Casey Planning Scheme Amendment C228

Expert Witness report provided to Planning Panels Victoria

Drainage Evidence

Prepared for the Victorian Planning Authority

Figure 4: Exhibited Minta Farm PSP

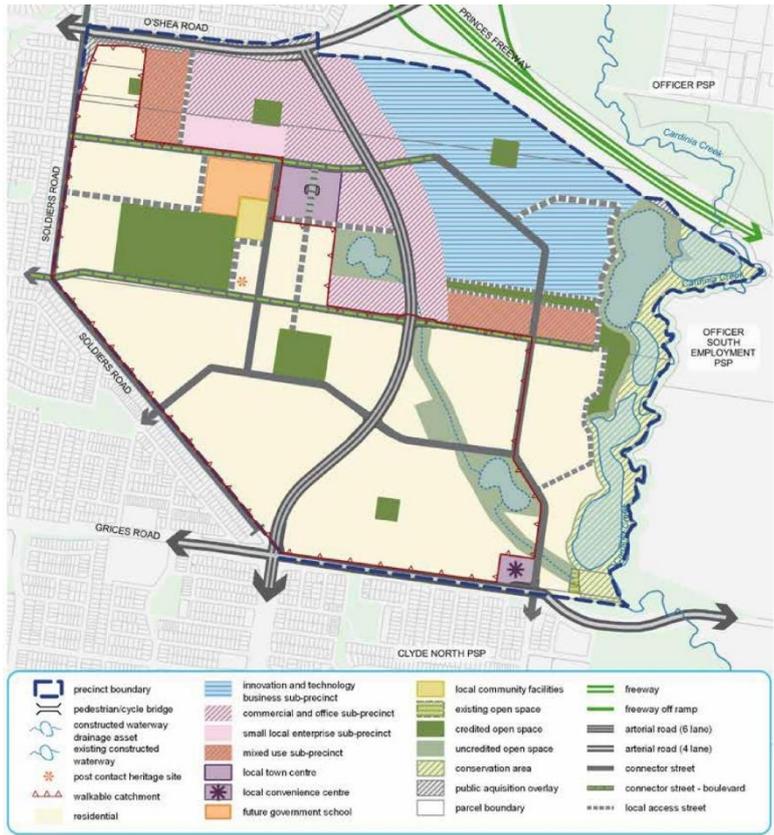
I have reviewed the strategy and the key issues are as follows:

- The interface and impact of the future urban drainage outfalls into the existing lakes/ponds and BCS corridor has not been addressed. This also included the connections and outfalls to Cardinia Creek. Consideration and understanding of the impacts of urbanisation on the existing environmental values is required through an eco-hydrology (e.g. seasonality) assessment.

- An external catchment area of around 50 ha north of the PSP has been diverted into the drainage system. Under current conditions the minor drainage pipe flows outfall east to the Cardinia Creek, whilst some overland flows in large rainfall events will travel south and into the PSP area. Diverting this extra catchment area transfers additional hydrologic and pollutant load into the Minta Farm PSP that needs to be managed. This potentially puts additional strain on the sensitive ecological areas along and adjacent to Cardinia Creek. Pond 1 is proposed to be converted to a constructed stormwater treatment wetland, however the maximise available size (within the nominated PSP reserve) for a wetland is 3.5 ha. Including the additional 50 ha external catchment results in additional drainage reserve land for stormwater treatment within the PSP area. From a financial perspective this additional treatment for external land would not be funded by the PSP landowners but would therefore need to be funded by Melbourne Water. Given that Melbourne Water's preferred option is for a drainage strategy and not a scheme, this may pose some difficulties to administer.

In my opinion the exhibited PSP and drainage strategy needs to be amended so that it integrates and responds to the existing site constraints and values. By its nature, implementation of the PSP and the corresponding land use change will dramatically alter the hydrologic regime that currently supports the existing habitat and ecological values. As a result it is imperative that the drainage strategy considers and integrates the needs of the following key pillars:

As a result I recommend that the PSP be amended to reflect the alternative configuration as presented in this evidence.

Figure 5: Background drainage strategy plan (Engeny, 2017) that informed the exhibited PSP

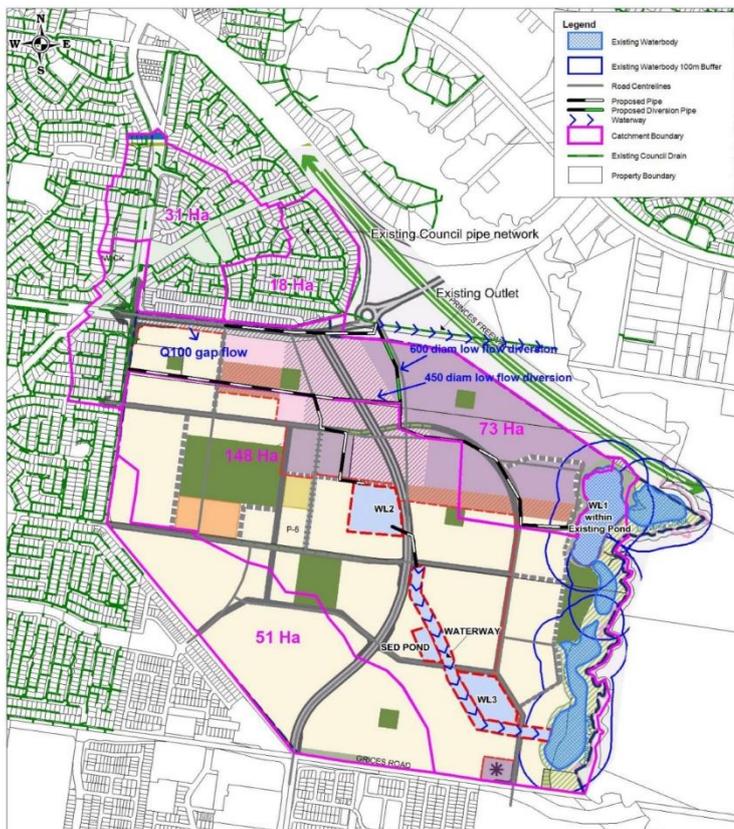
- The conversion of Pond 1 to a constructed treatment wetland does not address how flows interact with Pond 0, which has been identified by Biosis (see Section 6) as high value habitat for retention. The seasonality and ephemeral characteristics of this habitat area is important.

- Treatment wetland WL3 is located some distance to the west of Pond 3. Due to topography it may be difficult to drain all of the urban area to the east into the wetland. The outfall from WL3 is shown to only discharge to the lower end of the Pond 3, which is problematic in trying to manage the different seasonal hydrologic regime that the northern (shallow/ephemeral) and southern area require for habitat purposes (see Section 6). The location of WL3 does not provide the desired flexibility and adaptive management options to manage the hydrologic regimes to different zones.

- The condition of the existing pond embankments and their long term viability and safety have not been considered in the exhibited plan. The fate of the embankments are intrinsically linked to the drainage strategy and existing ecological values.

- The strategy for conveying overland flows through the town centre is a critical element of the drainage strategy, however this issue has not been specifically addressed
